Record of Decision Amendment
Poultney Street Site
Whitehall, Washington County, New York
Site Number 5-58-019

October 2008

**Poultney Street Site
Village of Whitehall, Washington County, New York
Site No. 558019
October 2008**

POULTNEY STREET
 EXTENT OF CONTAMINATION IN SOILS
URS
 FIGURE 2

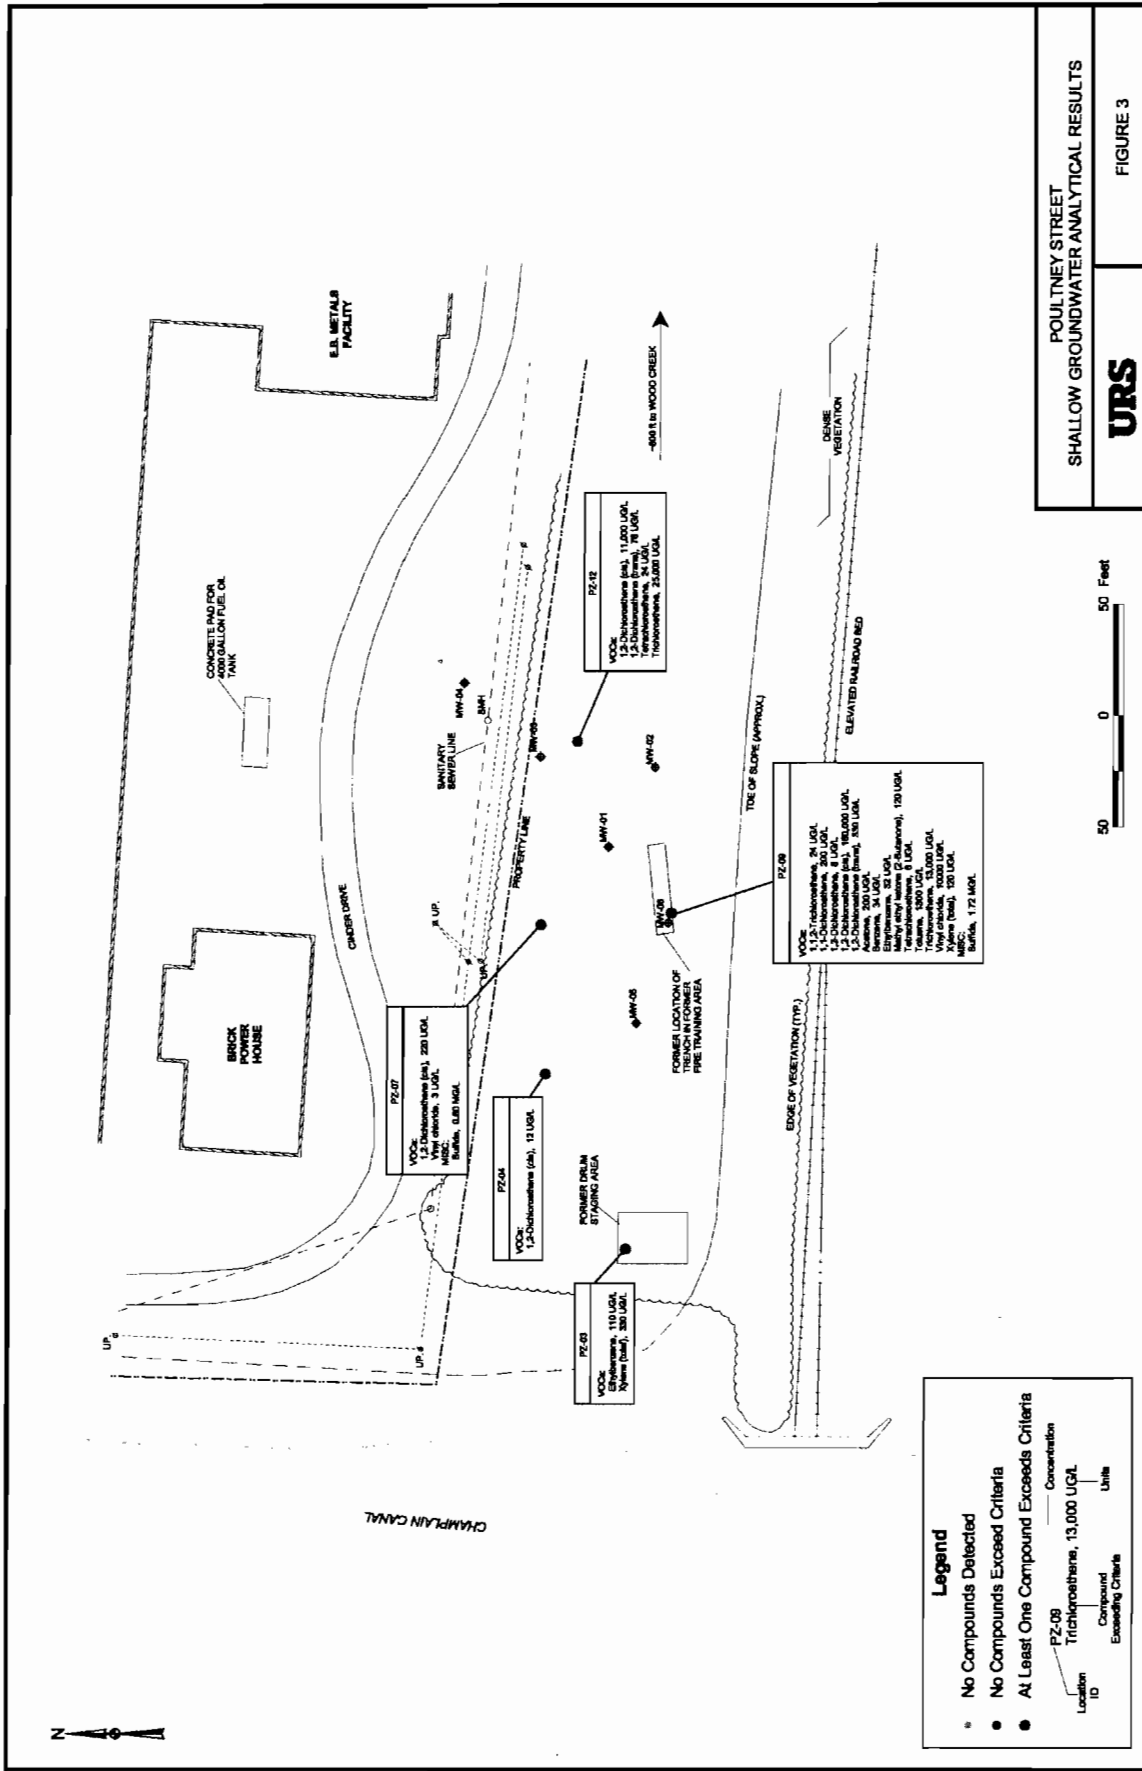
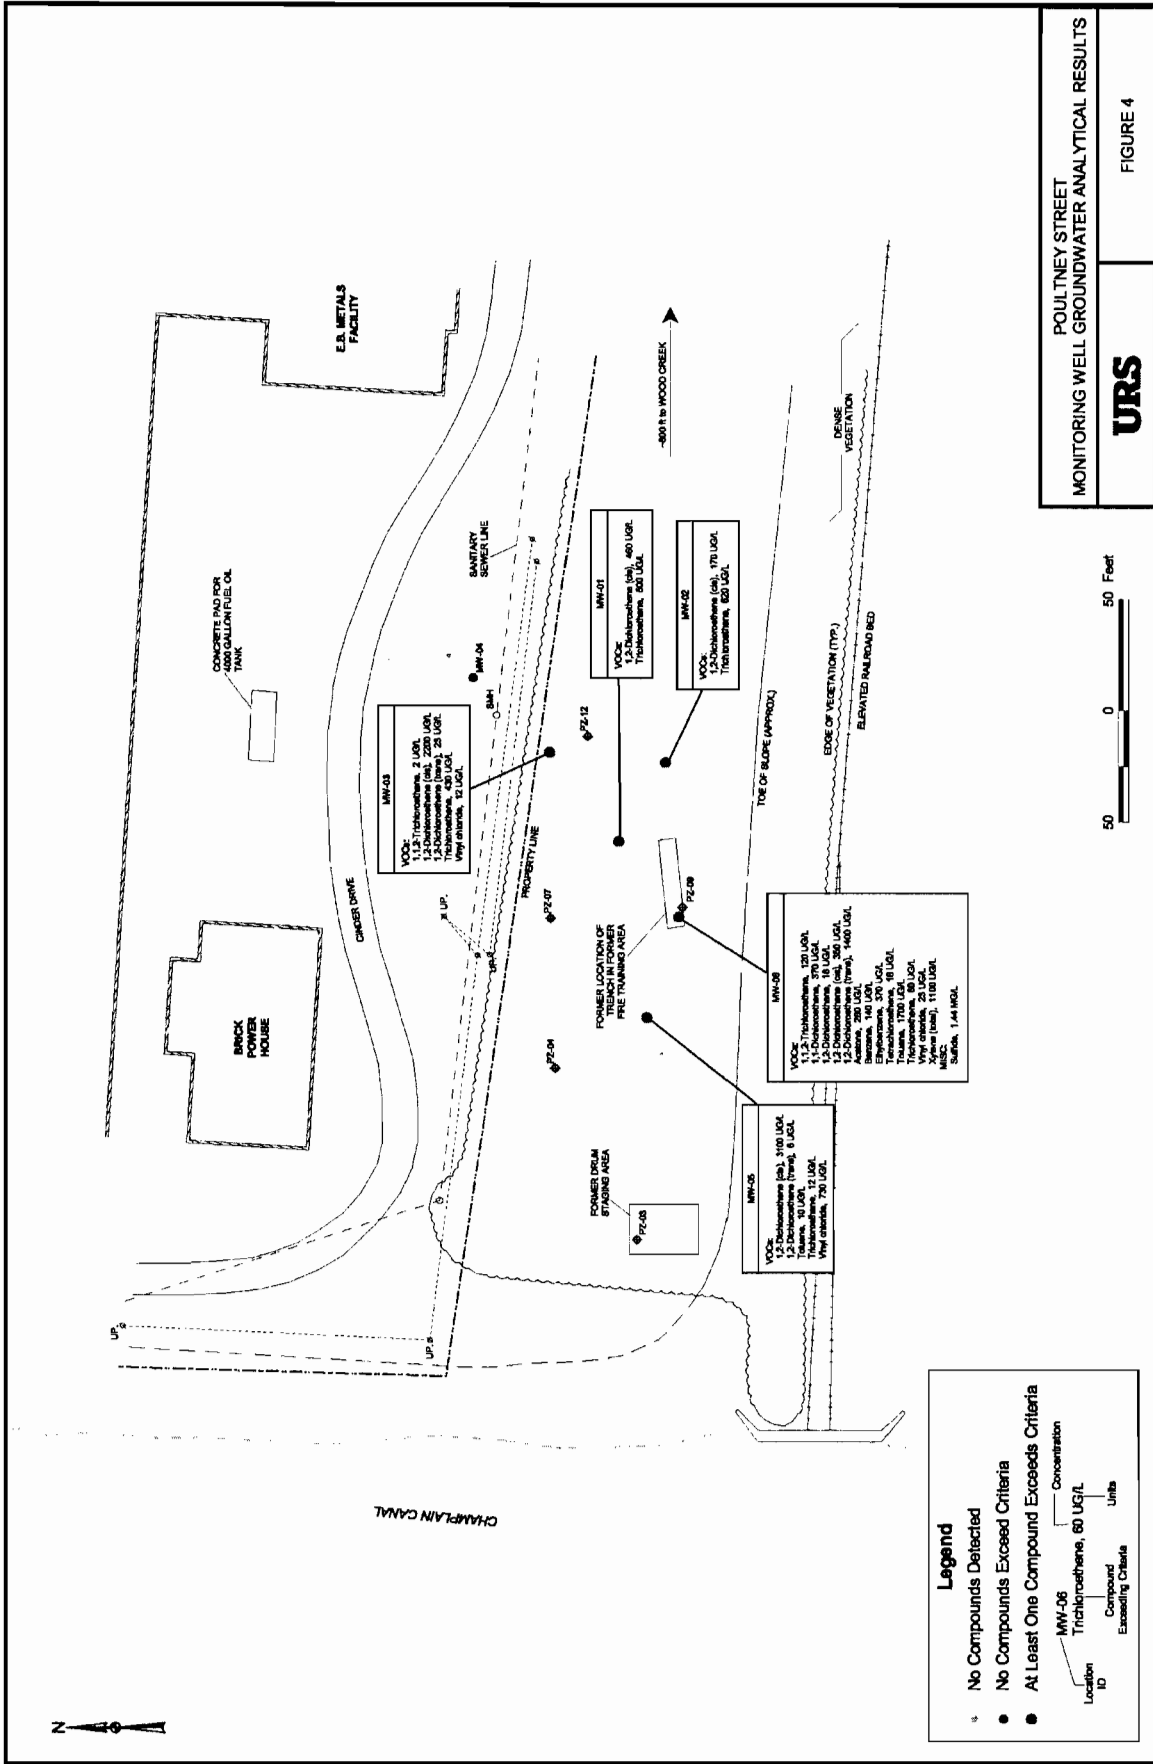
COMMENT 1: Where were the former trenches located?

COMMENT 3: Where is the property line between the former E.B. Metals site and the Poultney Street site?

COMMENT 4: Did you detect any contamination in soil borings SB-15 through SB-17?

RESPONSE 1: In the center of the site by the locations of monitoring well MW-6, and soil borings SB-11 and SB-12.

RESPONSE 3: Approximately 150 feet North of the rail line, in between MW-03 and SB-19.

RESPONSE 4: Not all of the soil borings were analyzed, however based on the photo ionization detector (PID) readings and laboratory analysis, no volatile or fuel/solvent contamination was detected.
